Miroo Desai, AICP
Planning Manager
City of Emeryville, CA

I am submitting these comments regarding the scope of the Environmental Impact Report for Sutter Health's proposed Emeryville Medical Center.

Issue: Safety Incompatibility of Traffic Diverted to 53rd Street

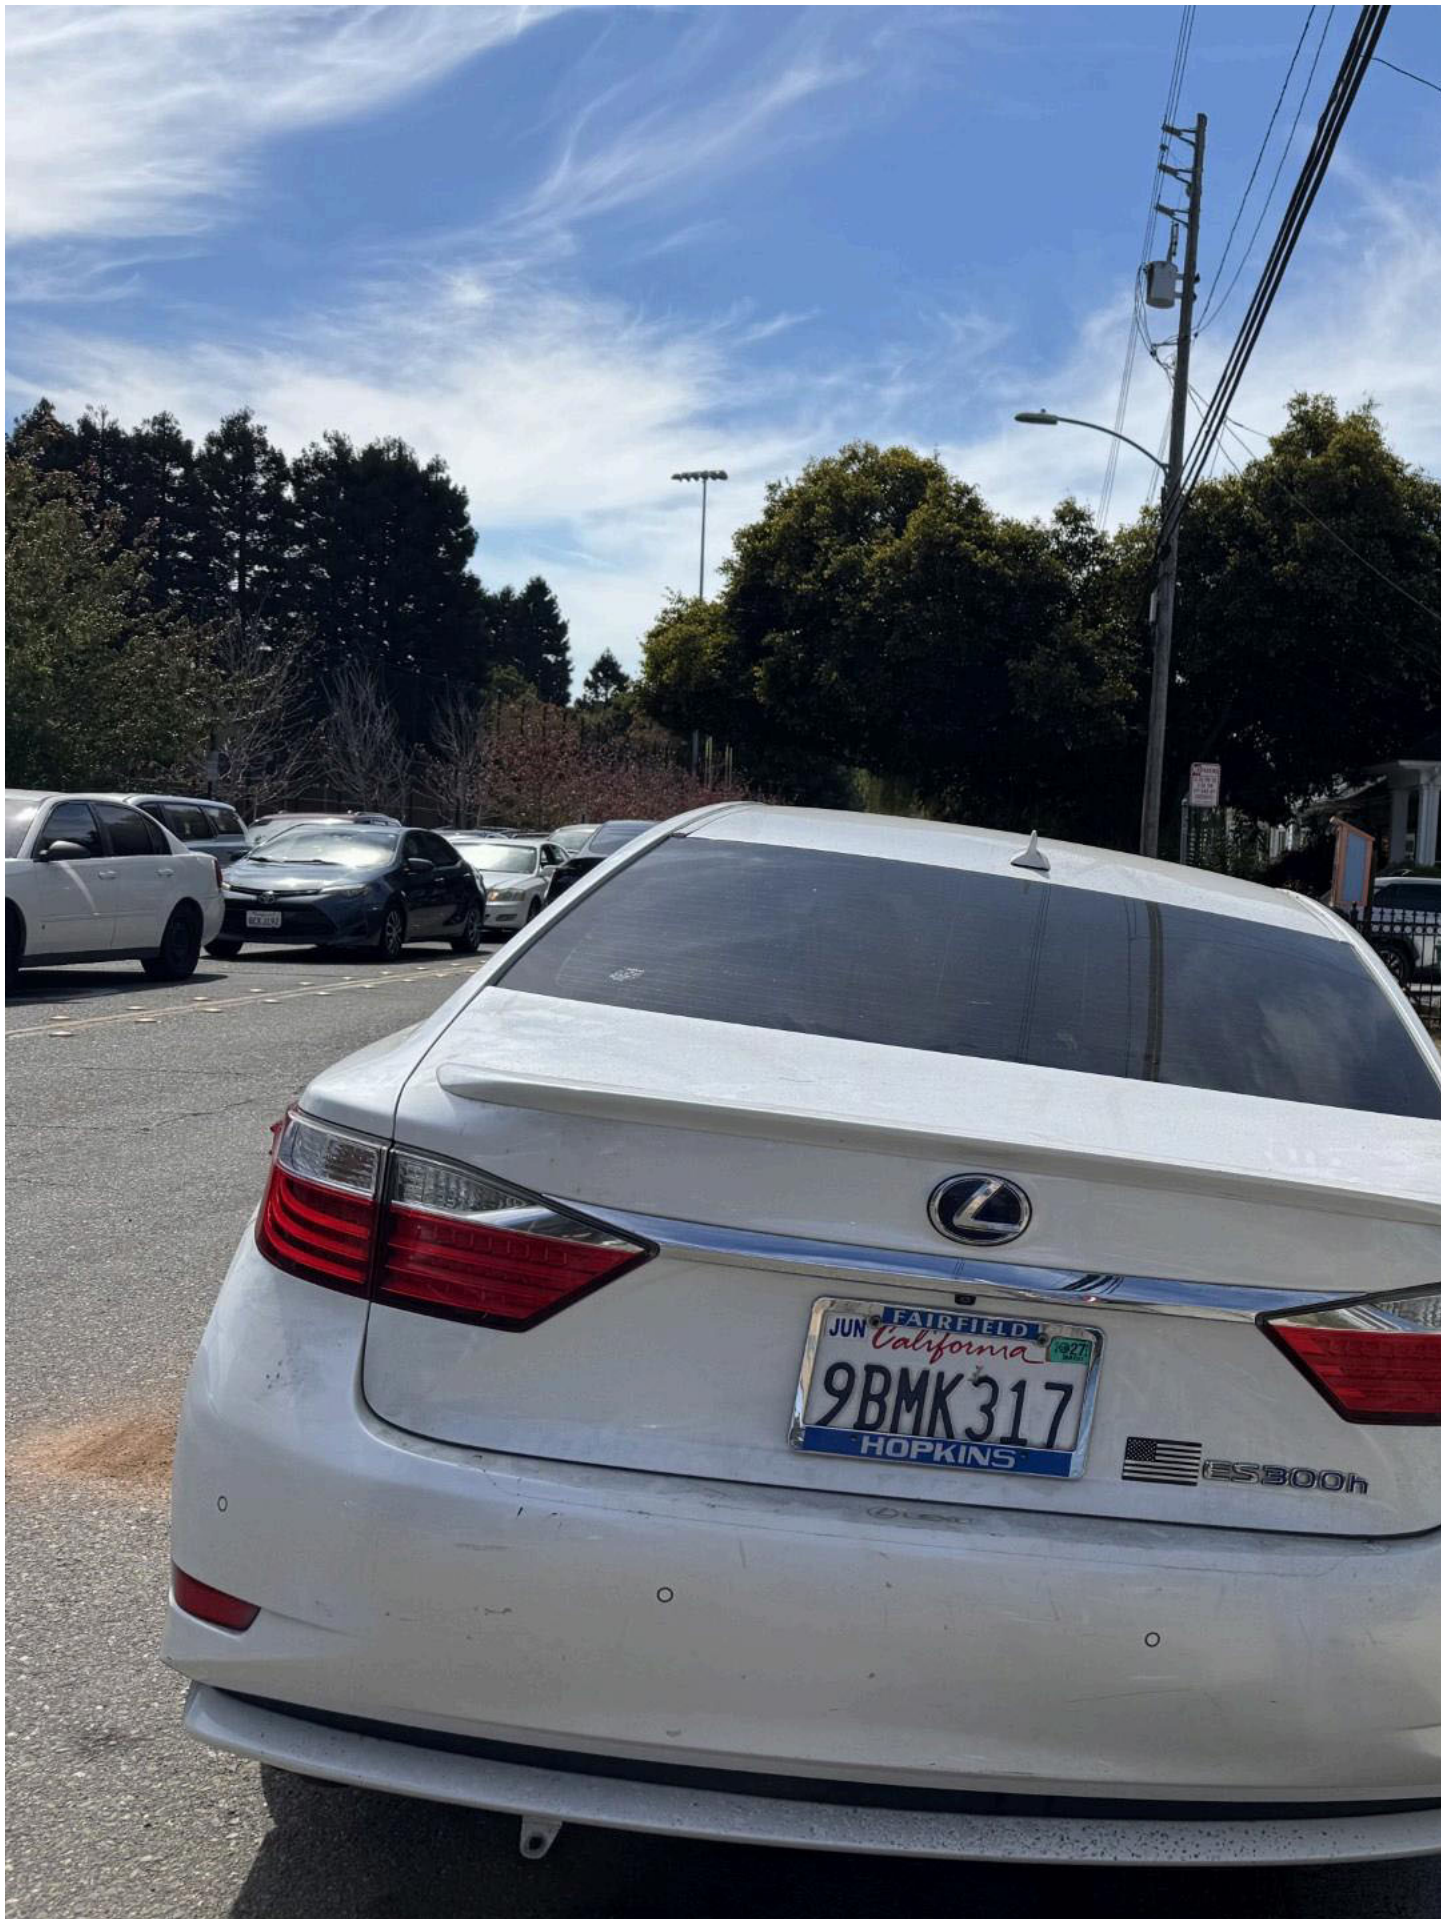
Legal Relevance under CEQA: This documentation provides substantial evidence of a severe structural bottleneck in the existing baseline grid that the Lead Agency's environmental analysis must address under CEQA Appendix G, Section XVII, Questions (a) & (c). Additionally, it demonstrates how local infrastructure has been intentionally modified by the City through multiple plans and programs to restrict rapid vehicle circulation in favor of multi-modal safety.^{1,2}

Request: The EIR must explicitly evaluate how the addition of the projected 1,500–1,800 peak-hour hospital vehicle trips can legally or physically reconcile with diverting high-volume vehicle flow through a 1 lane residential street (considered as "thoroughfare") with 2 schools (1 daycare, 1 K-12).

The EIR must consider the K-12 school drop-off and pickup site mitigation.

EXHIBIT E: Map of vulnerable populations around project site

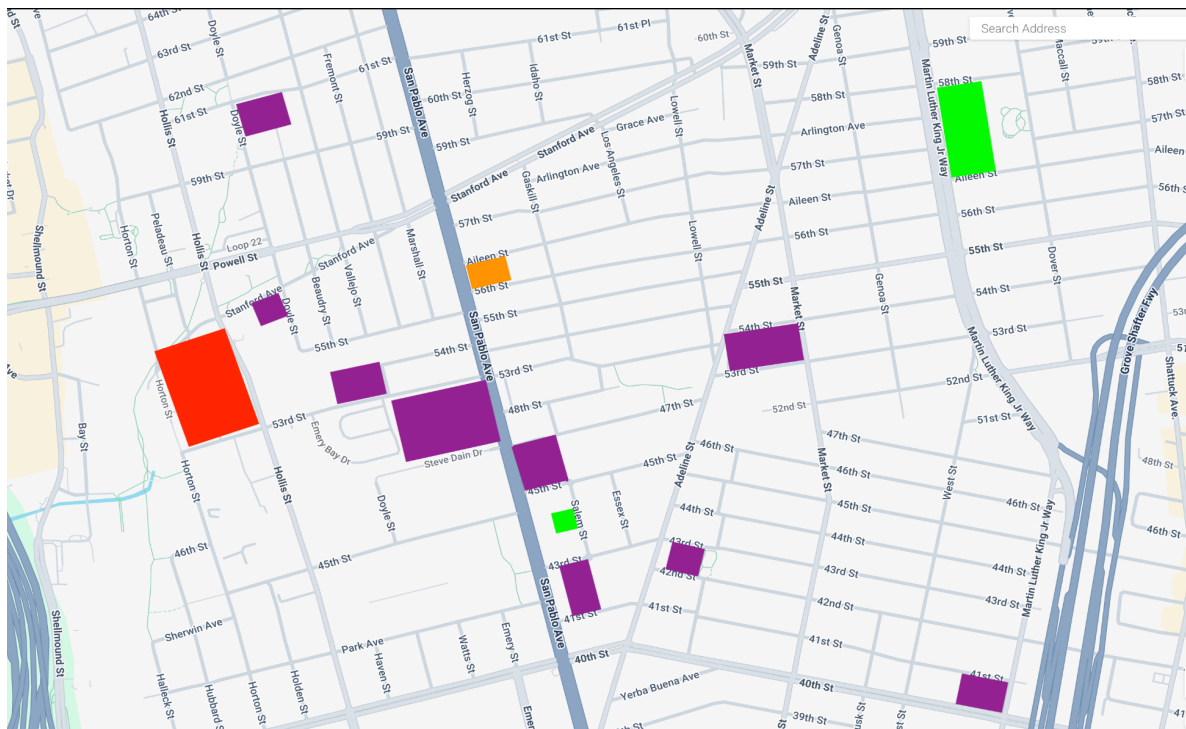
Legal relevance under CEQA: This spatial mapping documentation provides direct substantial evidence under CEQA Guidelines Section 15384 establishing the locations of high-density sensitive human receptors within the project's immediate zone of operational influence. The lead agency is notified that the presence of these specific institutional assets—including schools (purple), the Emeryville and North Oakland Senior Centers (green), and the Golden Gate Public Library (orange)—directly dictates the threshold of significance for non-exempt Air Quality, Noise, and Transportation Safety hazards under CEQA Appendix G.

Figure 5-3: Current Designated Pedestrian Priority Zones

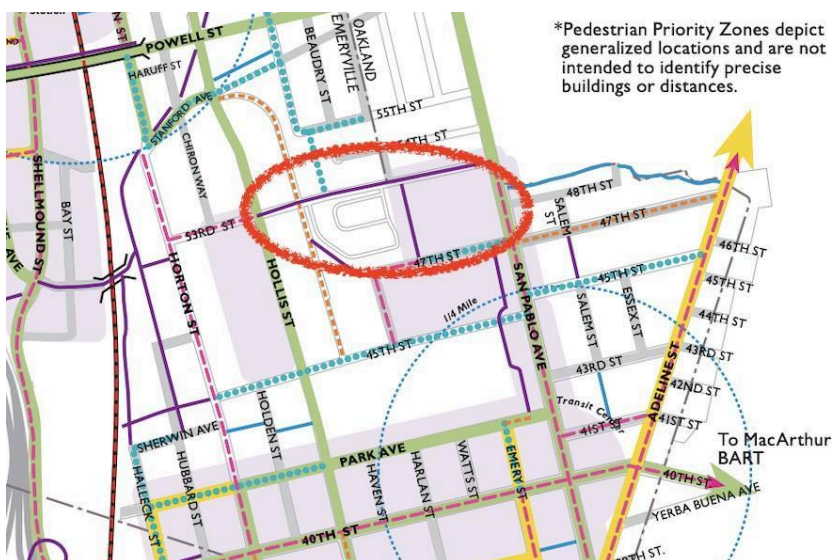
one block to get to school, but 53rd Street is not yet a pedestrian priority zone in the City of Emeryville General Plan (*See attached General Plan Figure 5-3*). While the school section itself is zoned as pedestrian priority, the street that most students use to get to school is not. The project should include amending the General Plan to apply Pedestrian Priority Zone designation to the entire 53rd Street between Hollis Street & San Pablo Avenue radius. Between Hollis Street and San Pablo Avenue, 53rd Street connects through Emery Bay Village multi-family housing, Spur Alley (including a youth gymnastics center), a preschool, an elementary school, a middle school, and a high school.
